General Bid Bulletin No. 12
29 November 2021

METRO MANILA SUBWAY PROJECT PHASE I

**PACKAGE CP102:
TWO UNDERGROUND STATIONS (QUEZON AVENUE AND EAST AVENUE)
AND TUNNELS
(IFB No: 21-034-6)**

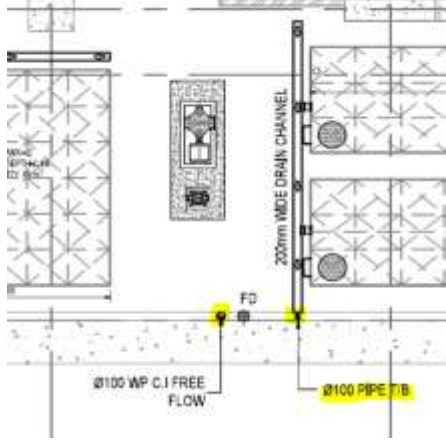
118.	SPL-C-DR-NA-1041 SPL-C-DR-NA-1042	Please provide Part 3 - Storm Drainage System Layout for North Avenue Station Plaza as reflected on the Key plan.	The area shown in the red box is out of scope.
